Access Compliance Report Public Rights-of-Way (Curb Ramps)

Main Street: DRUID_LN Cross Street: YELLOWTAIL_DR Location: SE

ADA ID: RPRK211207113718 Ramp Type: Type 4 - Parallel Initial Pass/Fail: Fail Overall Compliance: No Severity Score: 15

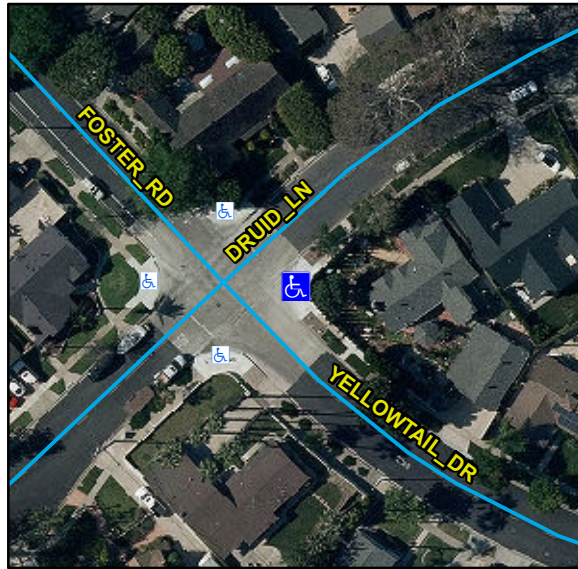
Compliance	Description	Data	Compliance	Description	Data
N/A	Ramp Length LT (in)	87	N/A	Ramp Length RT (in)	94
Yes	Ramp Width LT (in)	81	Yes	Ramp Width RT (in)	82
Yes	Ramp Run Slope LT (%)	1.1	Yes	Ramp Run Slope RT (%)	4.8
Yes	Ramp Cross Slope LT (%)	2	No	Ramp Cross Slope RT (%)	5.4
N/A	Landing Present	N/A	N/A	DWS Provided	N/A
N/A	Landing Length (in)	N/A	N/A	DWS Contrast	N/A
N/A	Landing Width (in)	N/A	N/A	DWS Length (in)	N/A
N/A	Landing Run Slope (%)	N/A	N/A	DWS Full Width	N/A
N/A	Landing Cross Slope (%)	N/A		DWS Offset Type	N/A
N/A	Landing Movement Obstructed?	N/A	N/A	DWS Offset Left (in)	N/A
	Landing Movement Type	N/A	N/A	DWS Offset Right (in)	N/A
N/A	Landing Shared	N/A			
N/A	Clear Space	Yes			
N/A	Clear Space To Crosswalk (in)	N/A			
N/A	Marked Crosswalk 1	No	N/A	Marked Crosswalk 2	No
	Crossing 1 Direction	N		Crossing 2 Direction	W
N/A	Marked Crosswalk 1 Width (in)	N/A		Marked Crosswalk 2 Width (in)	N/A

Remove & Replace Curb Ramp With Two New Directional Ramps or Equivalent.
